Change Order

Ketchum Fire Station #1
107 Saddle Road, Ketchum, ID

Change Order Number: 008
Date: August 11, 2021

See attached spreadsheet of seven items.

1 EXTERIOR ELEVATION - EAST
SCALE | 1/8" = 1'-0"

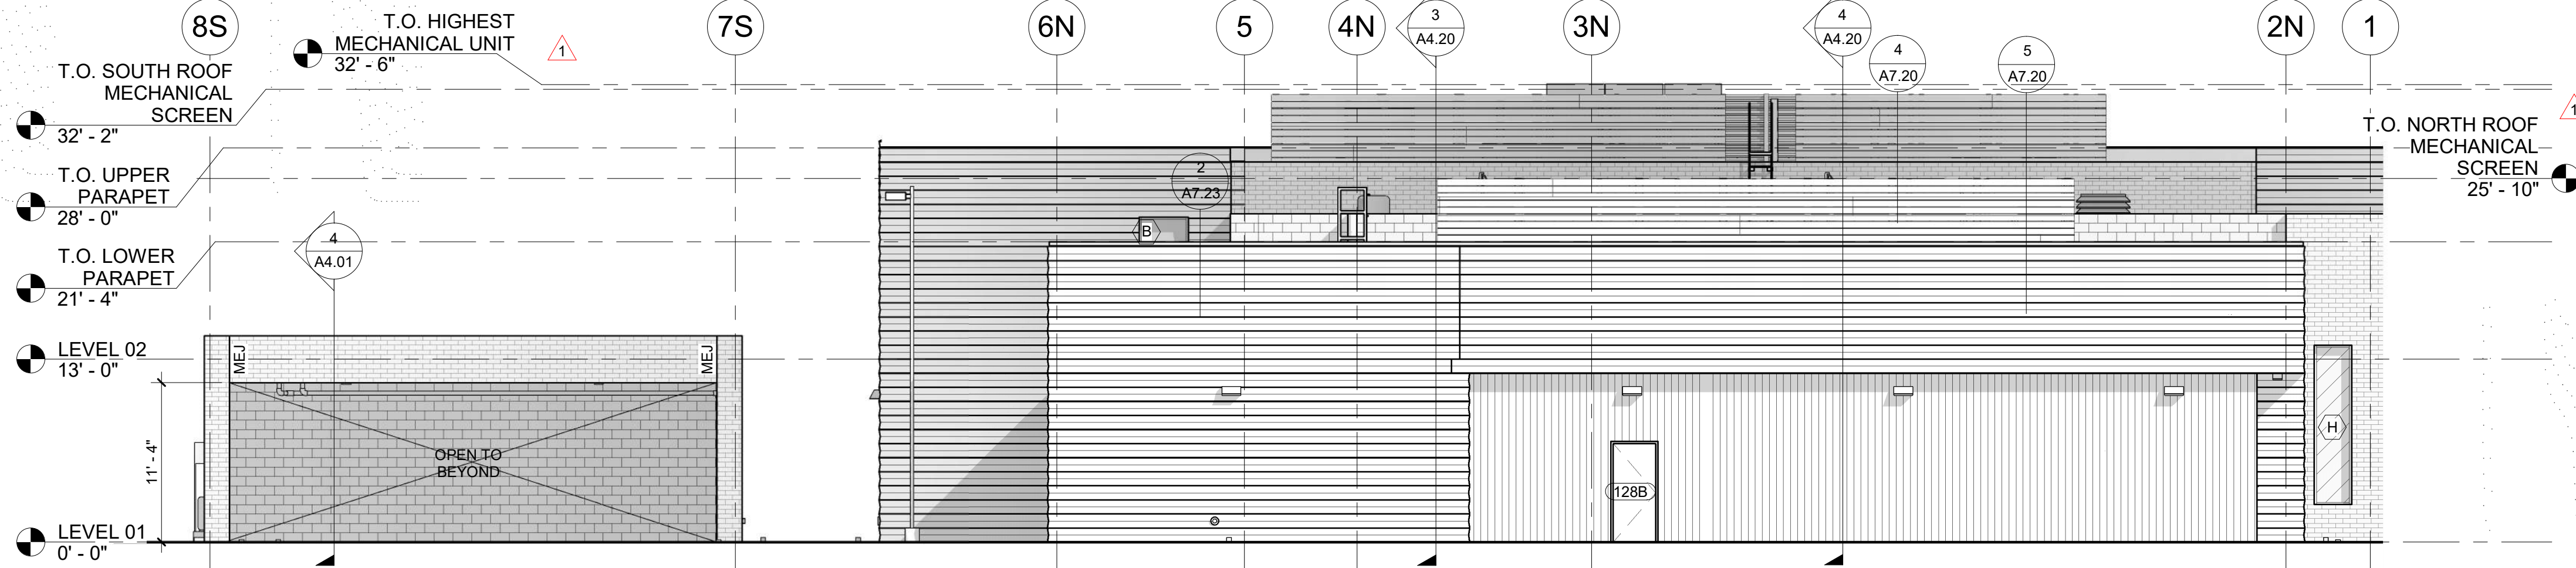
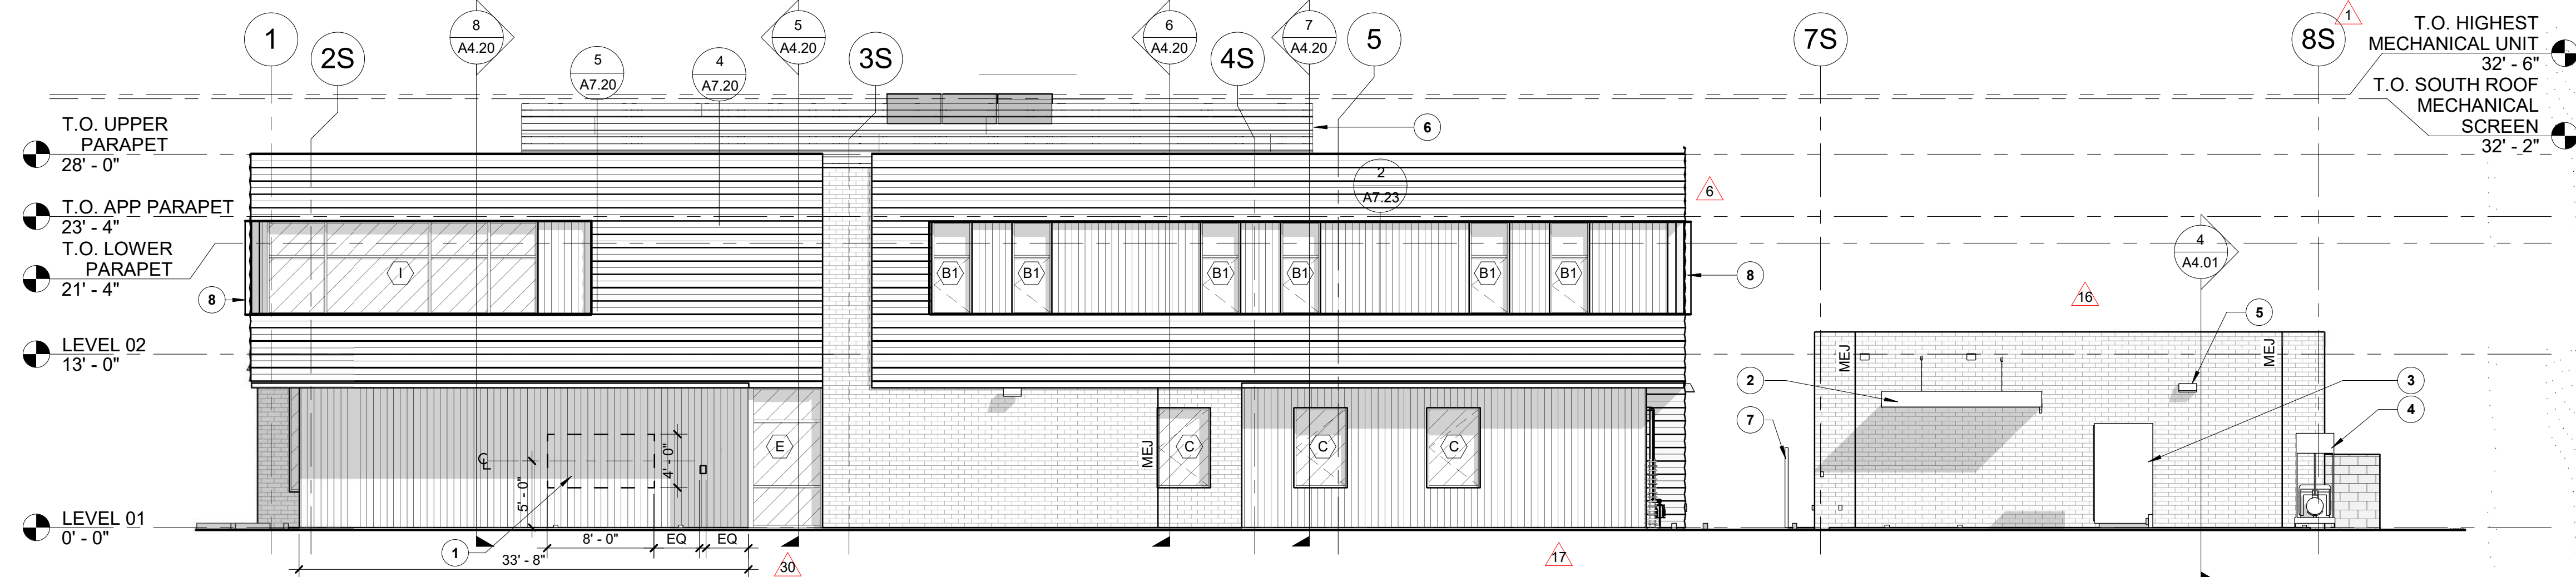
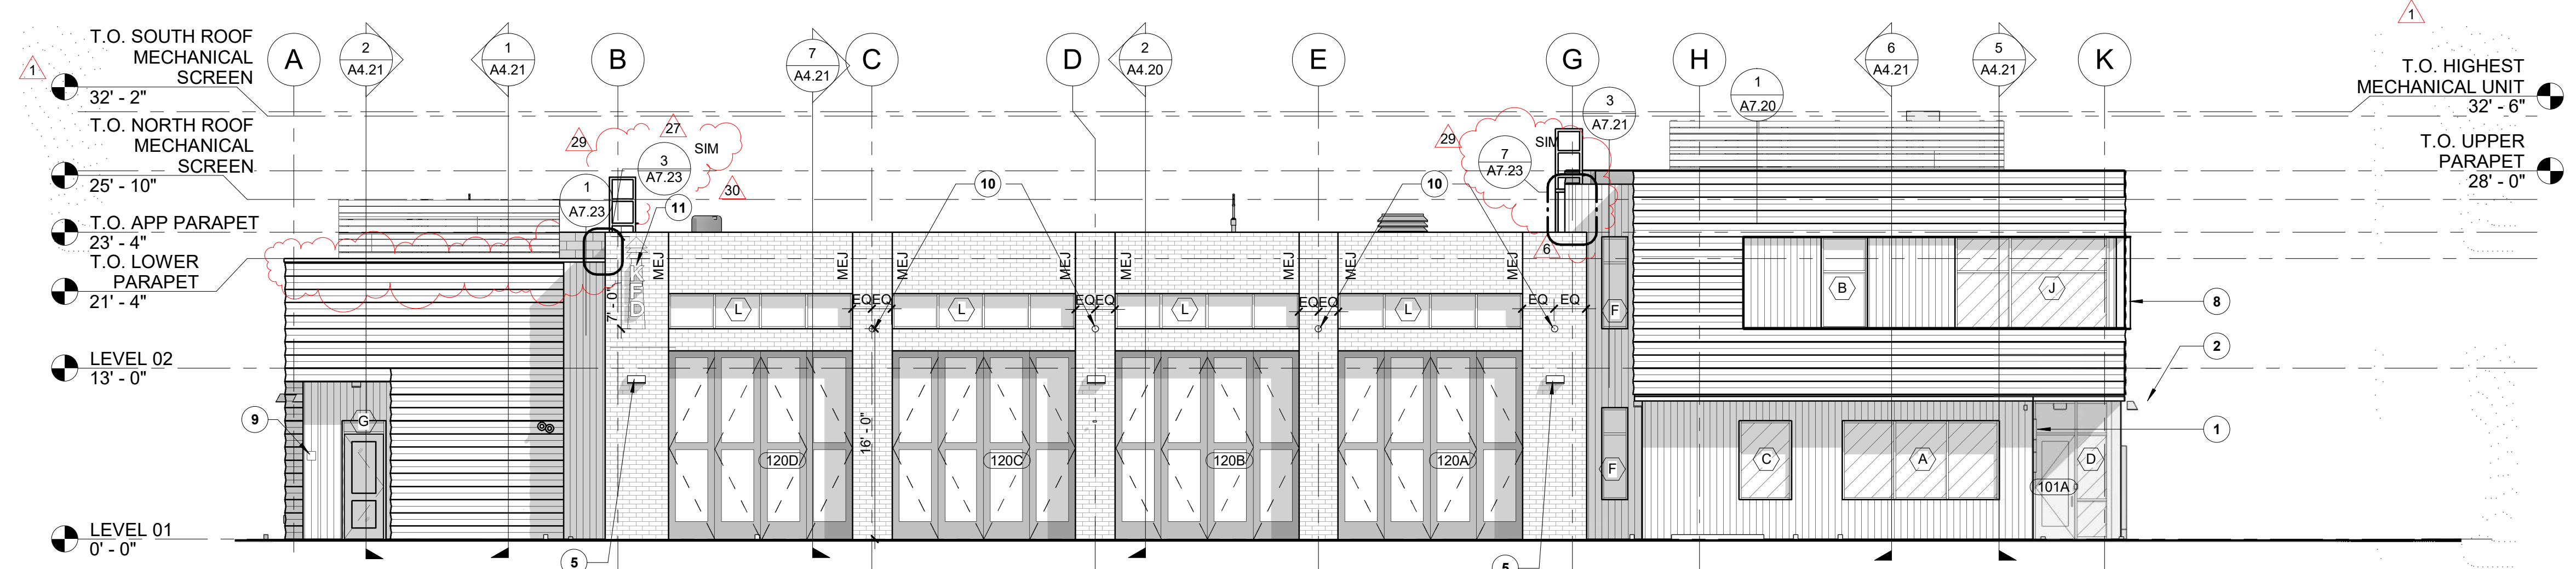
- 1) A3.00 – EXTERIOR ELEVATIONS
 - a) #1 – EXTERIOR ELEVATION – EAST
 - i) ADDED DETAIL CALL OUT.
 - b) #4 – EXTERIOR ELEVATION – WEST
 - i) UPDATED PARAPET HEIGHT.
 - ii) ADDED DETAIL CALL OUTS.
- 2) A7.00 – ROOF PLAN
 - a) ADDED FOUR DETAIL CALLOUTS FOR UPDATED DETAILS ON SHEETS A7.22 – DETAILS ROOF AND A7.23 – DETAILS ROOF.
- 3) A7.22 – DETAILS – ROOF
 - a) ADDED DETAIL #9 – PLAN VIEW PARAPET DEAIL @ GRIDS G & 5.
- 4) A7.23 – DETAILS - ROOF
 - a) ADDED DETAIL #3 – ISO PARAPET DETAIL @ GRIDS B & 2N.
 - b) ADDED DETAIL #4 – ISO PARAPET DETAIL @ GRIDS 5 & B.
 - c) ADDED DETAIL #5 – PLAN VIEW PARAPET DETAIL @ GRIDS B & 5.
 - d) ADDED DETAIL #6 – PARAPET PLAN DETAIL @ GRIDS G & 1.
 - e) ADDED DETAIL #7 – ISO PARAPET DETAIL @ GRIDS G & 1.
